Document:	Datasheet	Author /Date:	DHE / 28.12.2016
Version:	V1.0	Approved /Date:	FHA / 28.12.2016
Category:	Hand Pump

## Adapter Kit to Hand pump HPA-300118-B

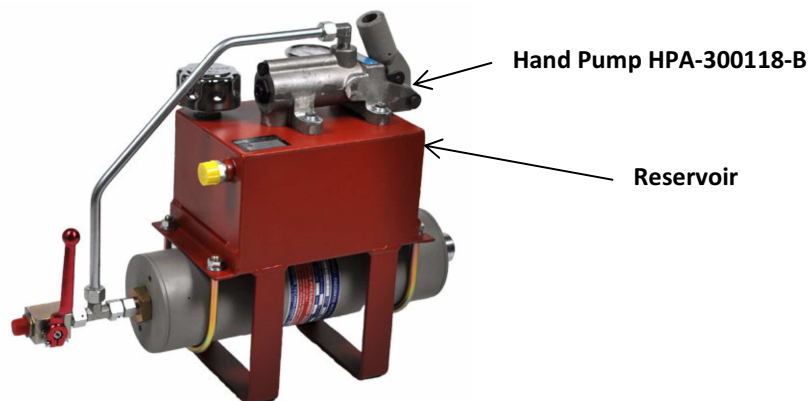
The old hand pump HPA-300118 is no longer available and has been replaced by the new model HPA-300118-B, with SAE porting.

To serve you with the right adapter kit, we kindly ask you to fill out the following form and to send it back to us, together with your HPA order.

## Adapter kit mounting on HPA-300118-B

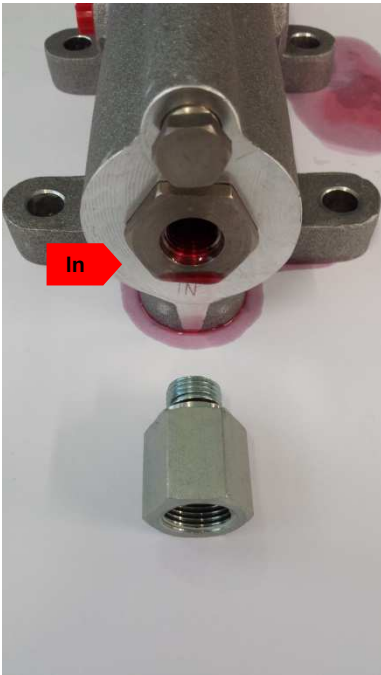
Fig. 1+2: Adapter SAE 6 to 3/8" NPTF for In-/Outlet ports (for stand-alone HPA).

Fig. 3: Adapter SAE 4 to 1/4" NPTF for Gauge port.

Fig. 4: Inlet tube SAE 6 with O-Ring for Inlet (for HPA mounted on CPS reservoir).
